CITY OF MARLBOROUGH MEETING POSTING

Meeting Name: Conservation Commission
Date: June 18, 2020 (Thursday)
Time: 7:00 PM
Location: Will be conducted via remote participation

- 7:20 Notice of Intent (212-1220) (Continuation)
Rte. 20 reconstruction from Peters Ave. to Marlborough/Sudbury town line - MassDOT
Proposes to reconstruct Rte 20 from Peters Ave. to the Marlborough/Sudbury town line. They will replace deteriorated pavement structures, widen the travel way to safe and acceptable lane and shoulder widths, adding new sidewalks and provide upgrades to the existing drainage system. Several sections of this work are within the buffer zone to wetlands.

Crossing: Broad Meadow Existing - 100 yr

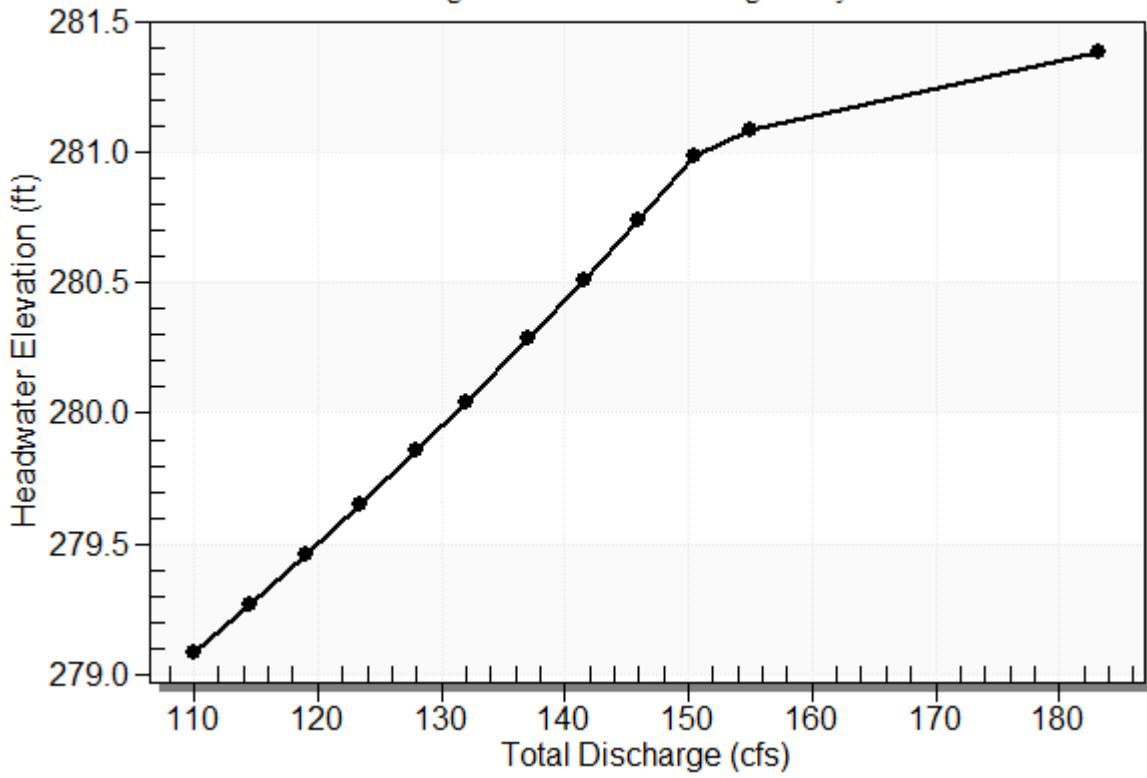
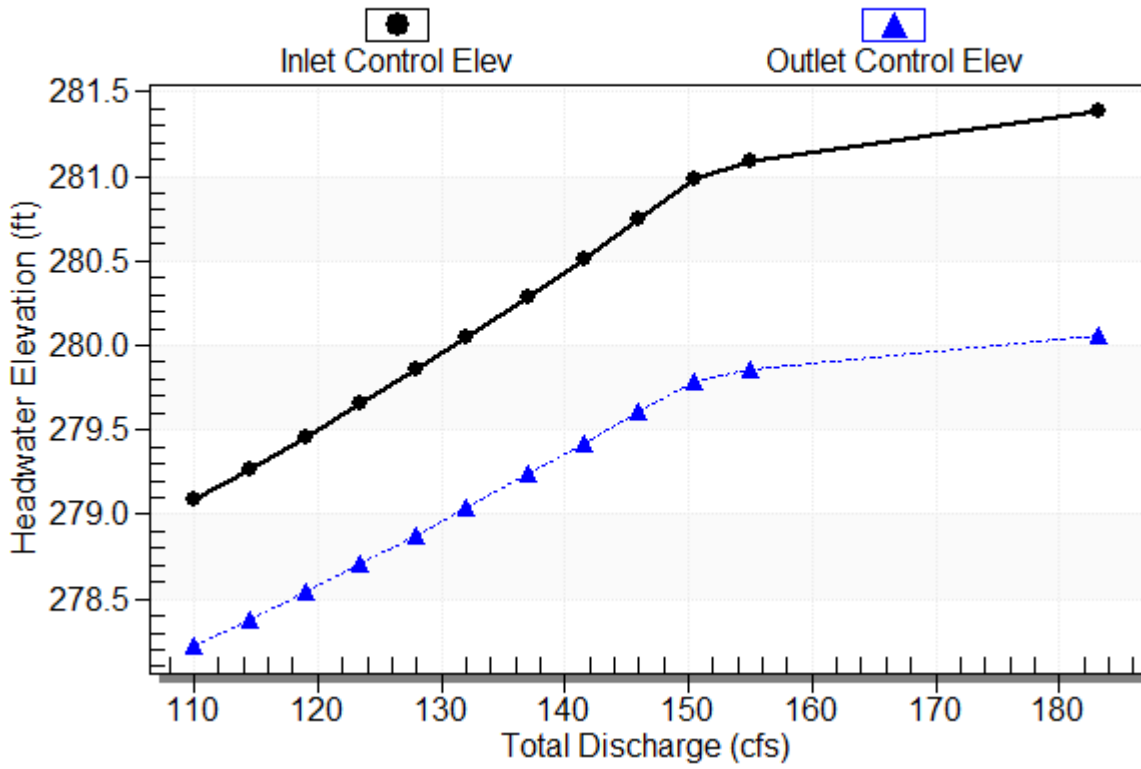
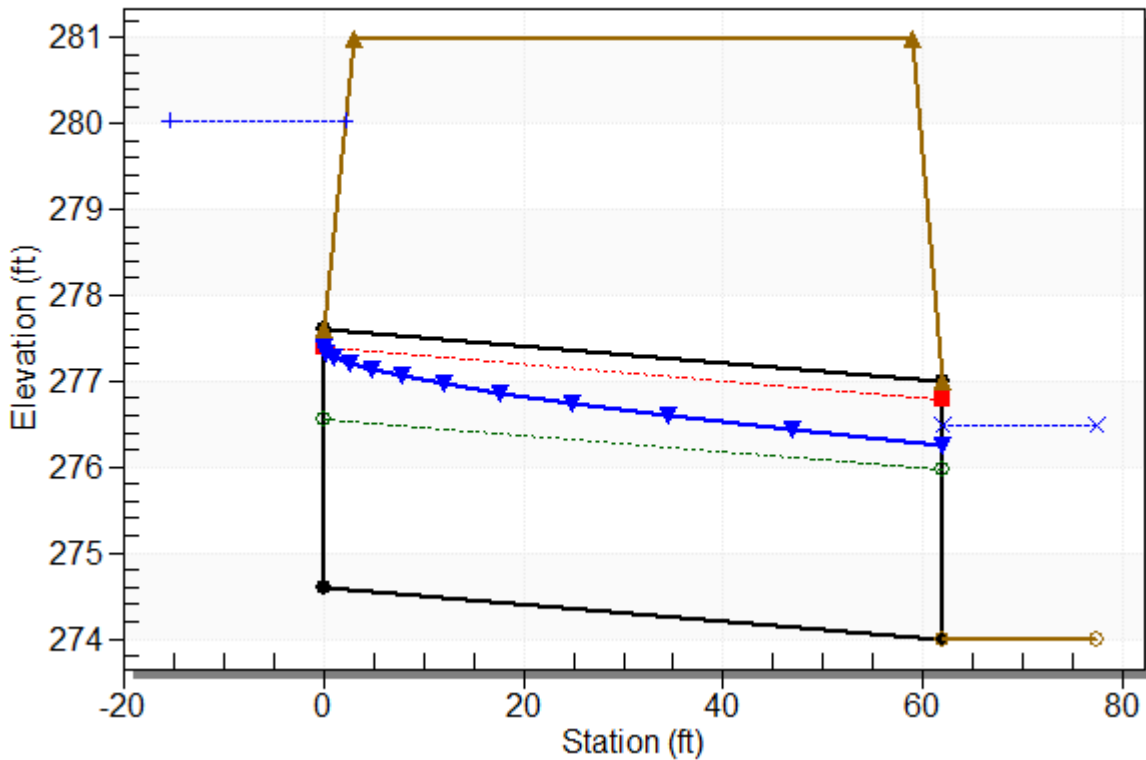
Comment 2: *Peak flows increase for all design storms for the overall project, with significant increases proposed at Design Point 3 (Broad Meadow Brook). The applicant should verify that the proposed increases in peak flows will not cause damage or flooding to downstream properties or infrastructure.*

Response 2: Two different calculations were used to determine if there would be any downstream damage or flooding caused by the proposed discharge at design point No.3.

1. Stream Stats was used to determine the 100-year flow entering the culvert (132 cfs). The HY-8 program was used to analyze the existing 100-year storm event on the downstream side (outlet) of the culvert to determine the depth of flow and elevation (276.50 ft.). The 100-year storm event flow from the discharge of design point No.3 (5 cfs) was added to the Stream Status flow to determine the stream elevation during a 100-year storm event (276.53 ft.). The addition of the 100-year storm from design point No.3 increased the stream elevation by 0.03 ft. The existing and proposed HY-8 culvert analysis results & Stream Stats flow data are provided in Attachment A.

2. Manning's equation for open channel flow was used to determine a stream elevation approximately 20 ft. downstream from the outlet of culvert. The cross-section was determined from the existing conditions survey. The Stream Stats flow for the 100-year storm event was used to determine the depth of the stream and elevation using the manning's equation for open channel flow. The elevation was determined to be 276.50 ft. The 100-year storm event flow from the discharge of design point No.3 was added to the Stream Stats flow to determine the stream depth and elevation (276.54 ft.). The addition of the 100-year storm from design point No.3 increased the stream elevation by 0.04 ft. The existing and proposed open flow calculations are provided in Attachment C. The 100-year flood elevation provided by FEMA flood map on the downstream side of the culvert is 276.4 ft.
